Office Action Summary	Application No. 10/699,389	Applicant(s) CHEUNG, CHUNG	
	Examiner Evan H. Langdon	Art Unit 3654

DETAILED ACTION

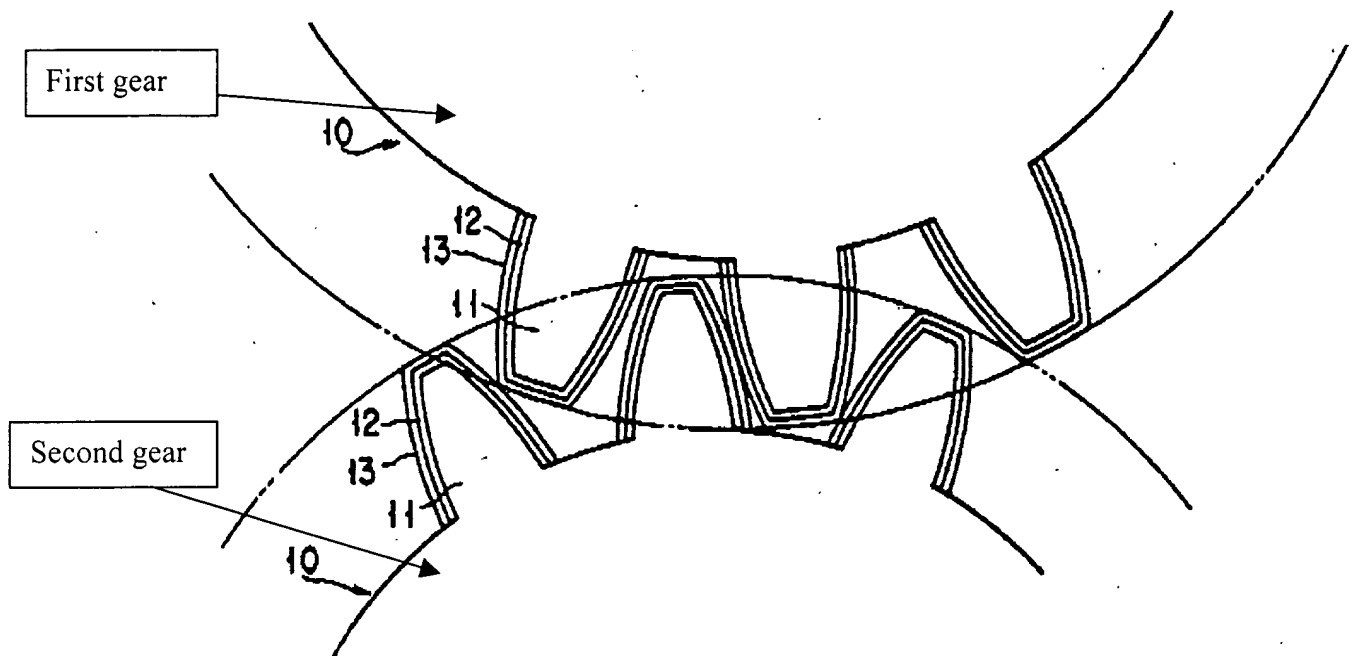
In regards to claim 12, Honda discloses a gear couple comprising:

a first gear 10 having a first gear surface and a first gear outer layer 13 which includes gold (col. 2, line 36); a first intermediate layer 12 between the first gear surface and the first gear outer layer 13; a second intermediate layer (manganese phosphate layer and chromium nitrate layer, col. 2 line 65 – col. 3 line 2) between the first gear outer layer and the first gear surface;

a second gear 10 (see below) having a second gear surface and a second gear outer layer which includes chromium 12 (col. 2, line 65-67), wherein the first layer and the second layer engage in meshing contact.
